Case No. 2025-00177
Barrelhead Solar, LLC
Response to Siting Board's Second Request for Information

Siting Board 2-1:

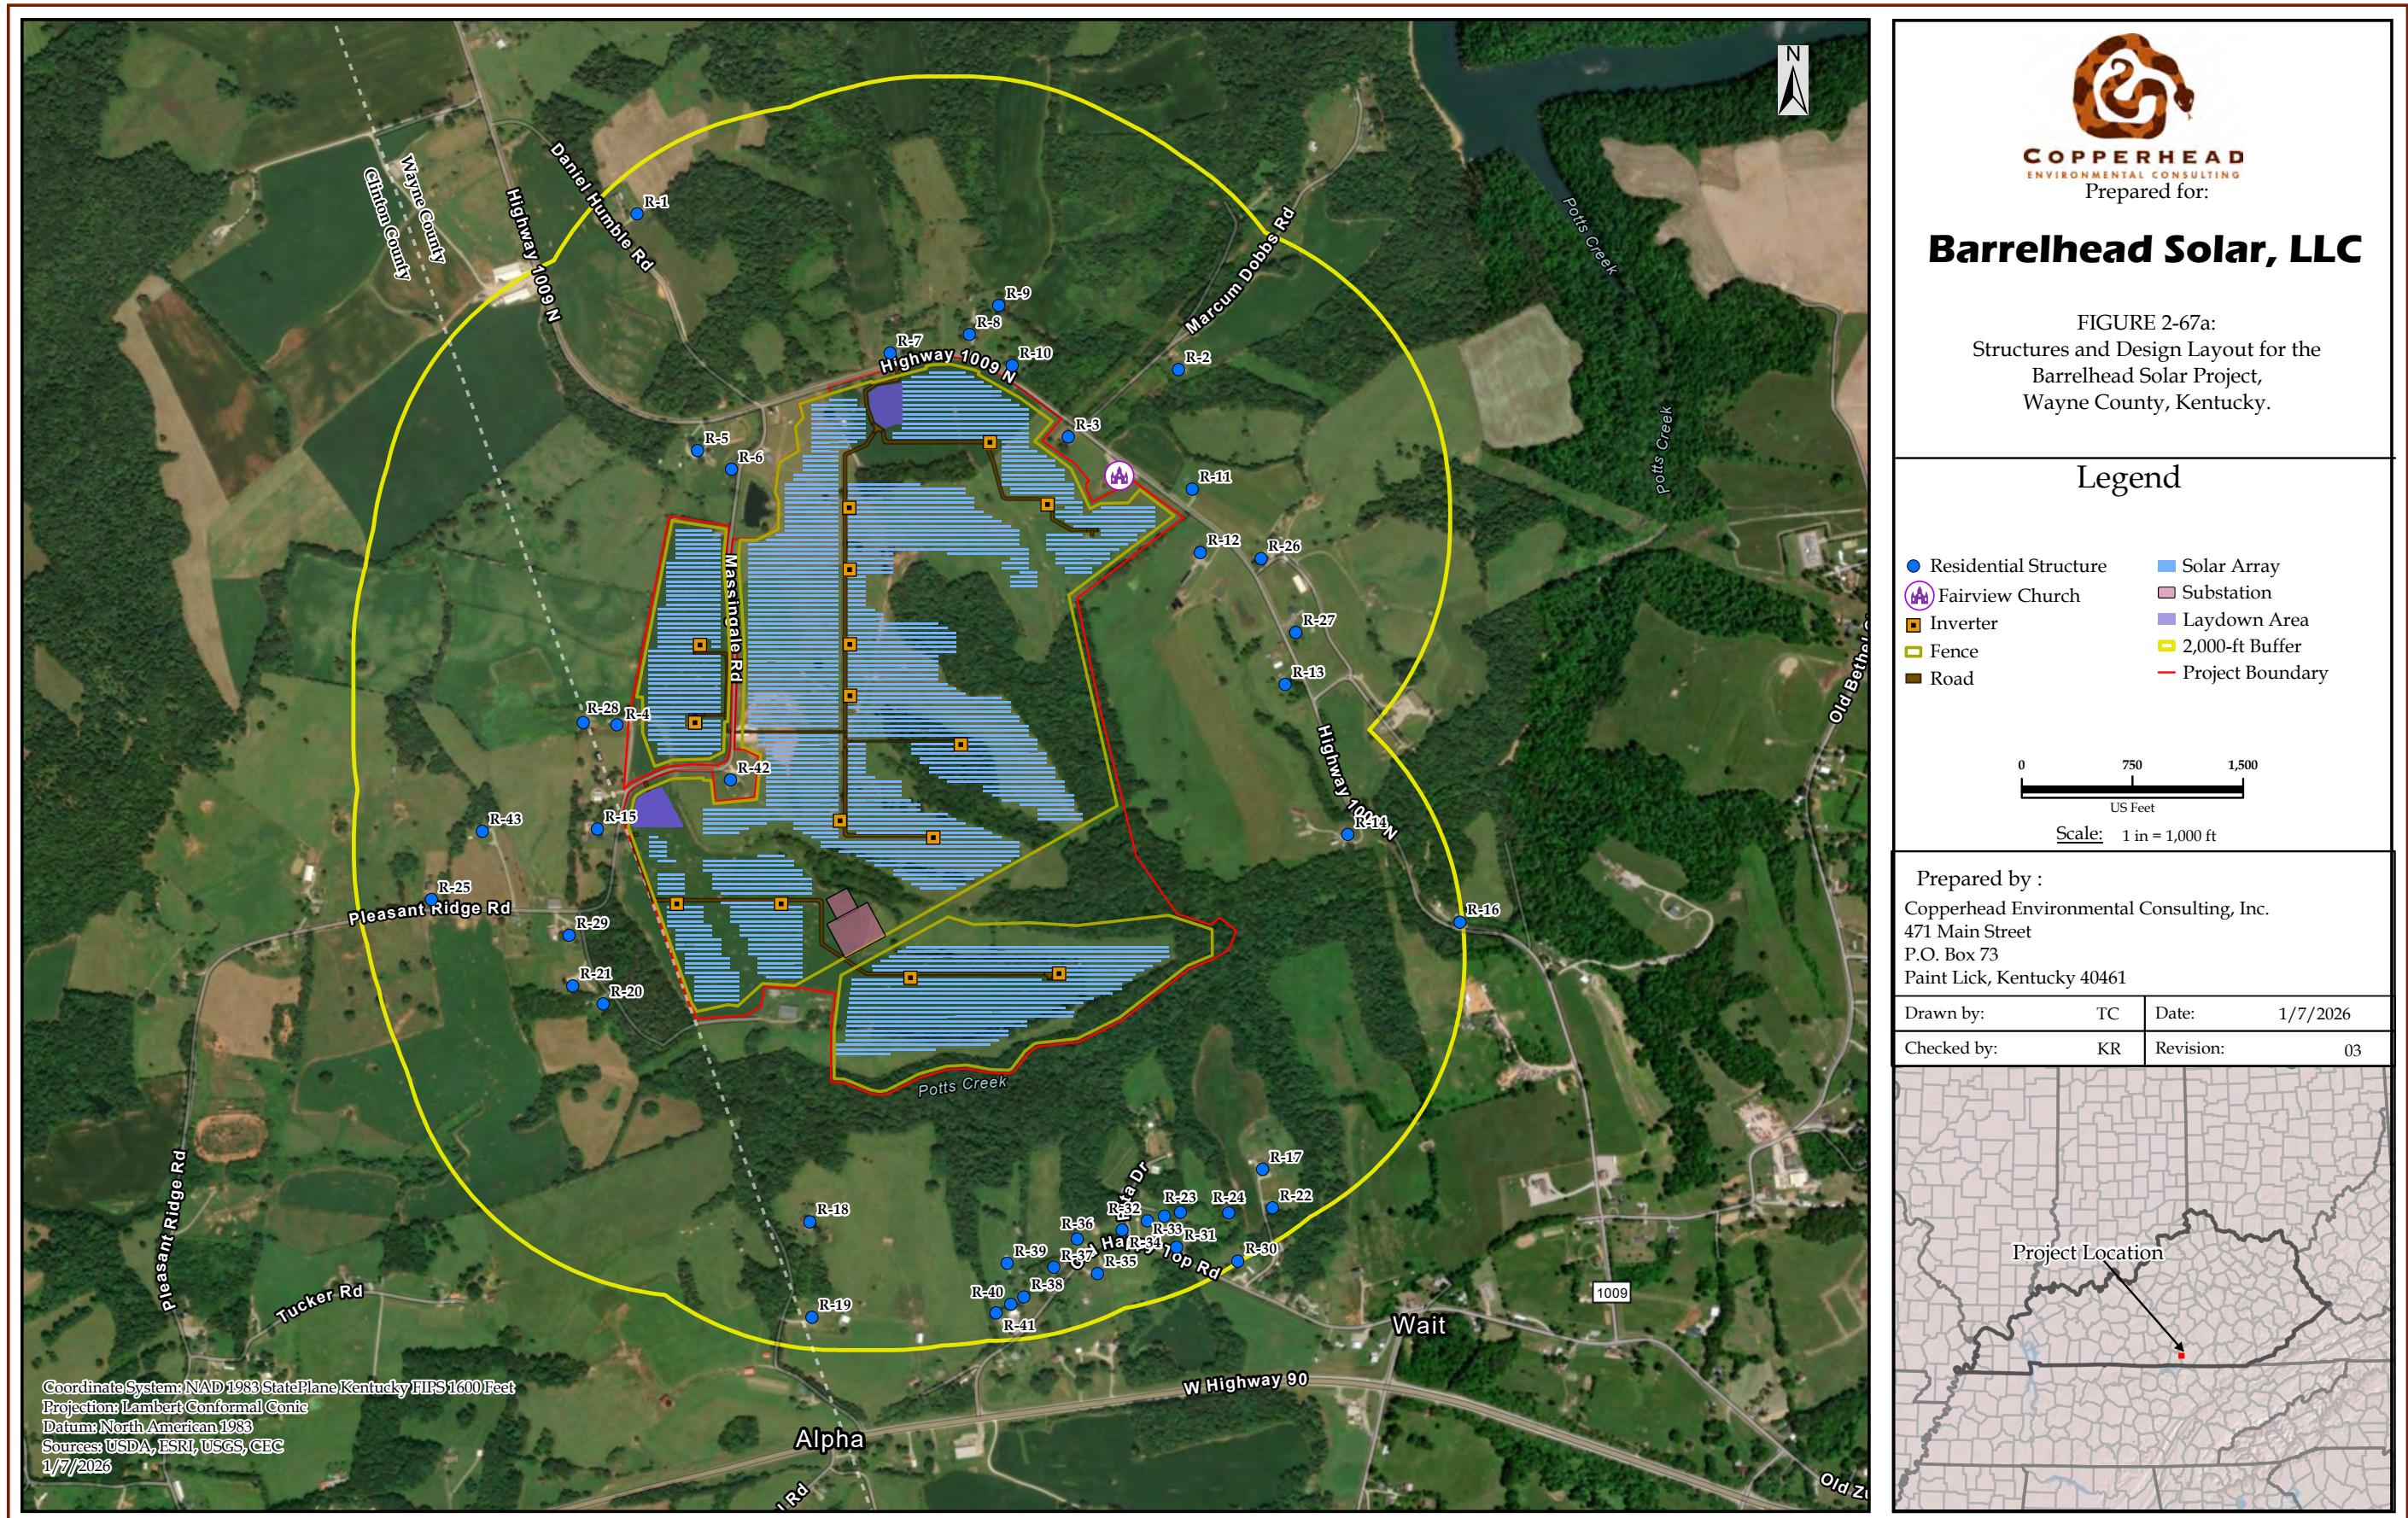
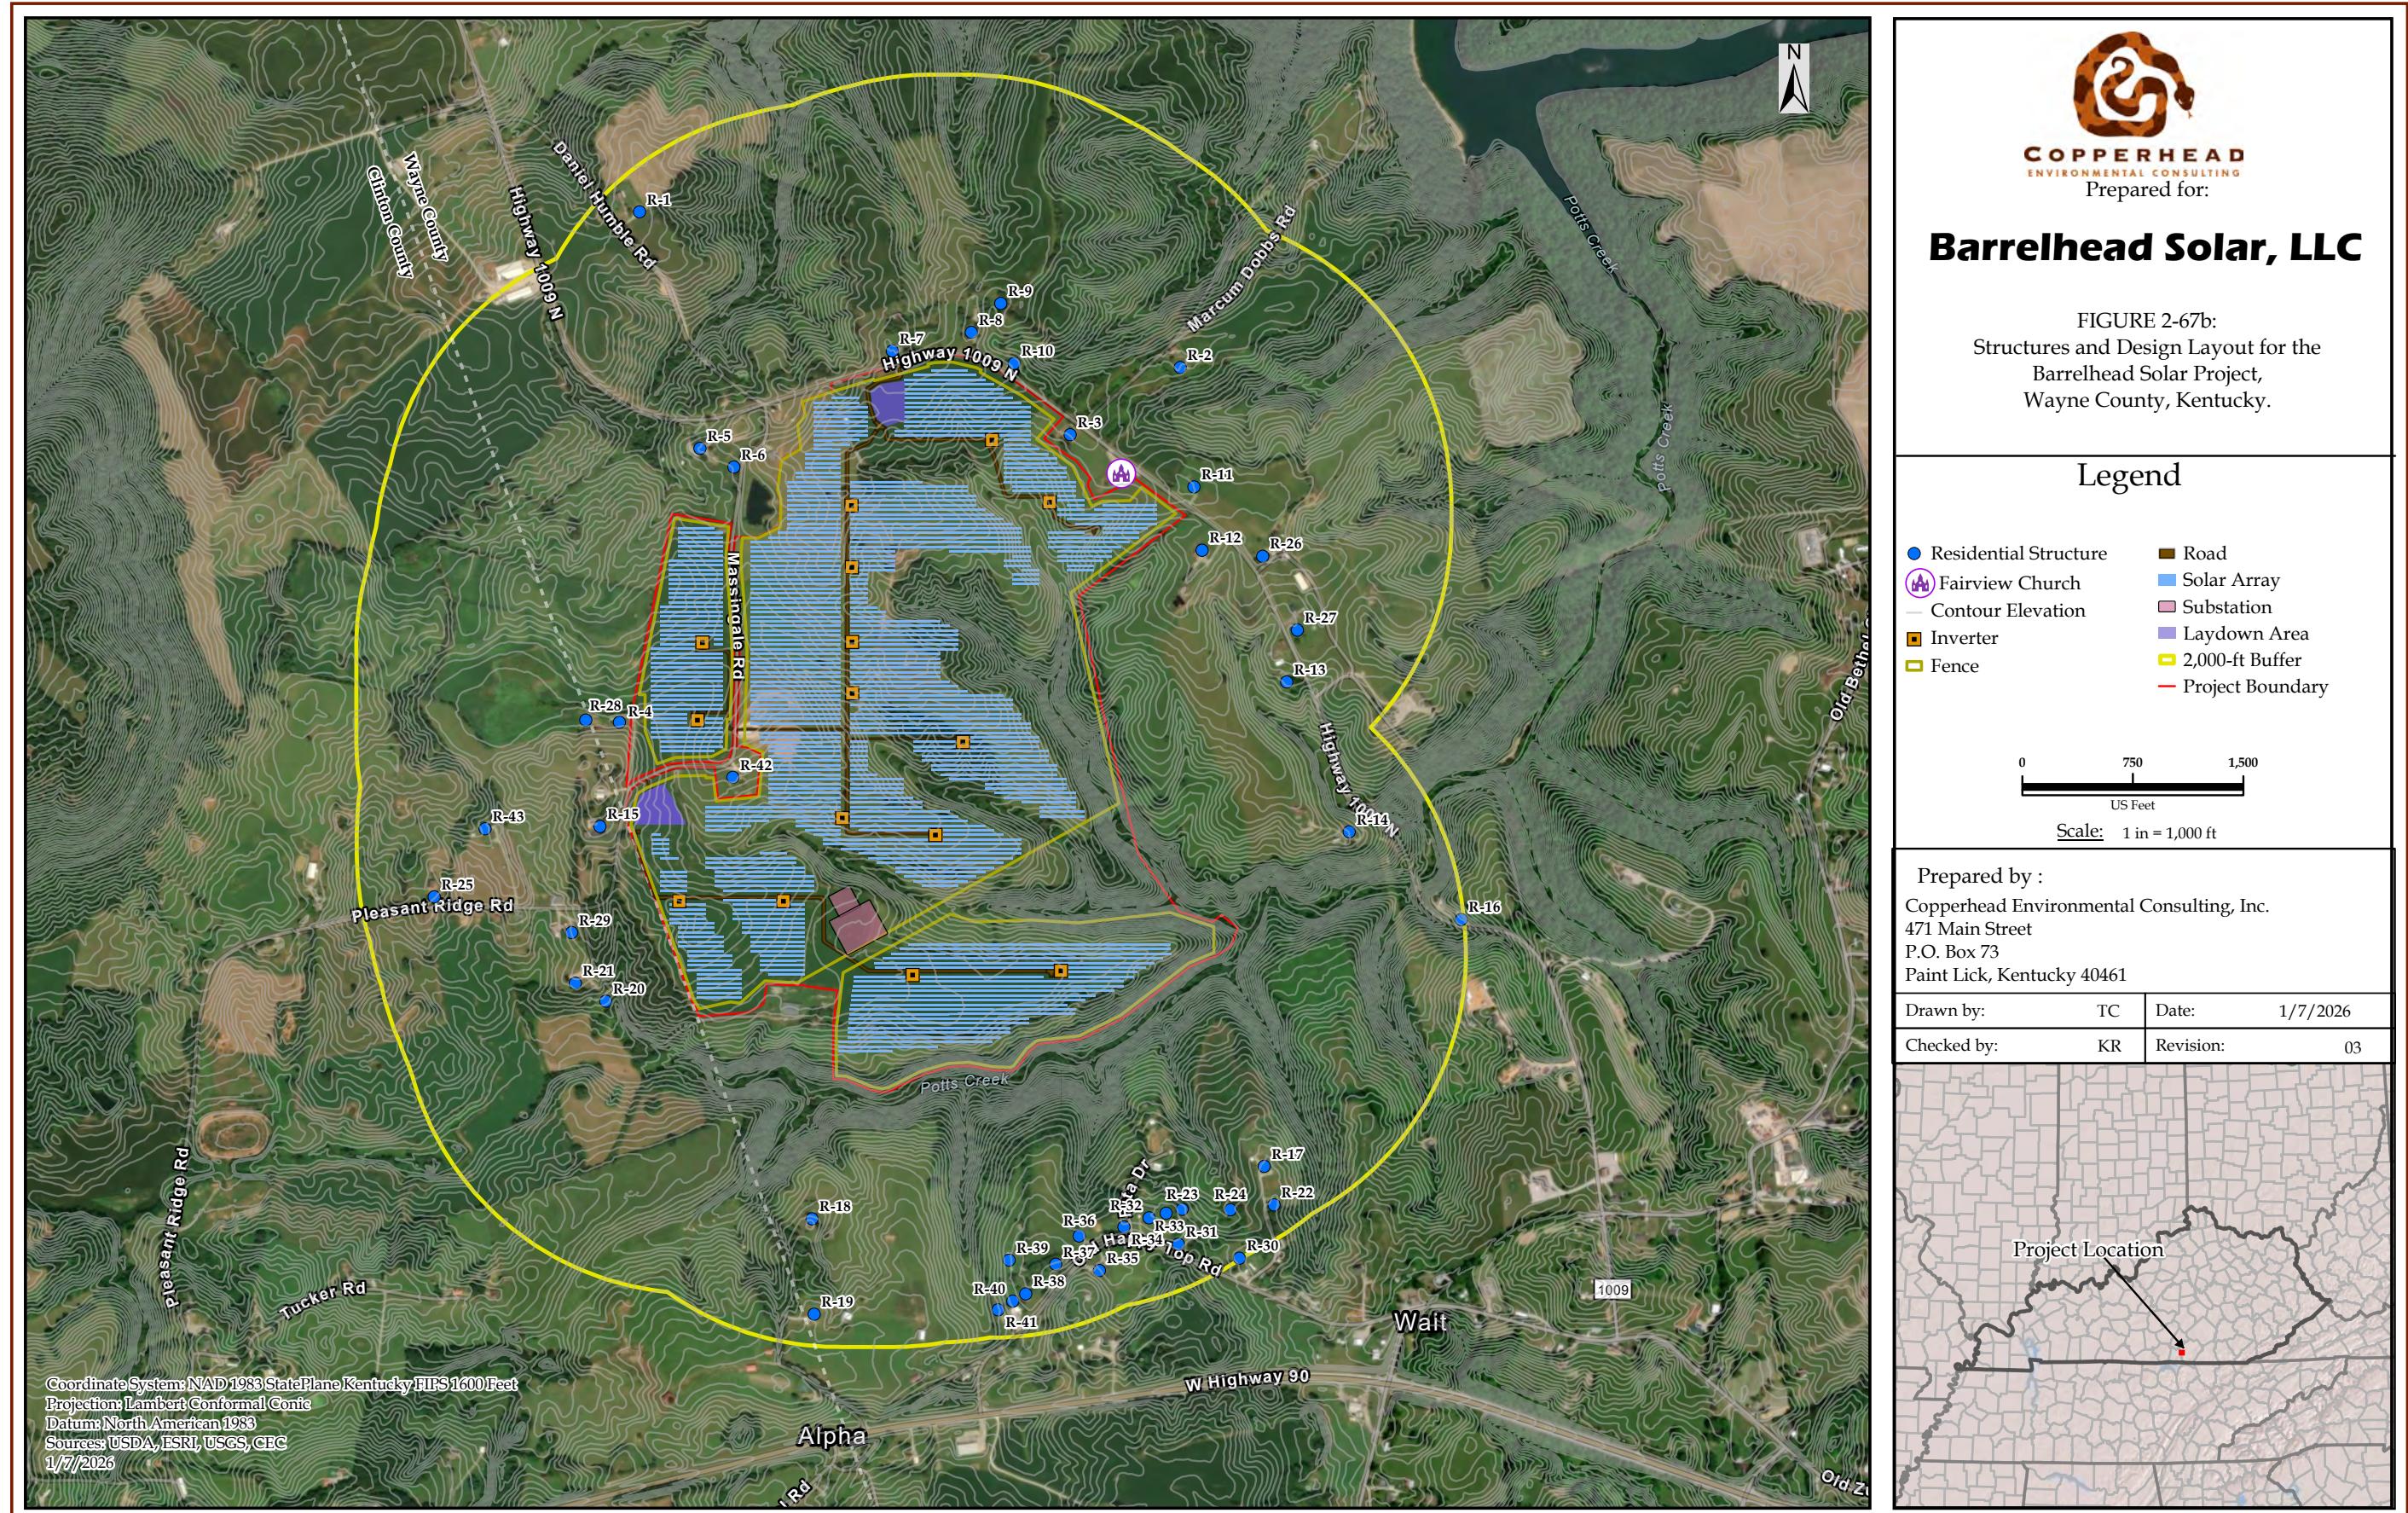
Refer to Barrelhead Solar's response to Staff's First Request, Item 59. Figures 1 and 2 include a different total number of receptors and different numbering system for the receptors than shown in Figure 3. Explain these differences and provide revised Figures with consistent receptor numbering.

Response: Figures 1, 2, and 3 from the visibility analysis have been revised and provided as Attachment 2-67. The numbering system in the revised maps uses the updated/simplified labeling developed for this RFI. The difference in numbering between the previous maps was clerical error.
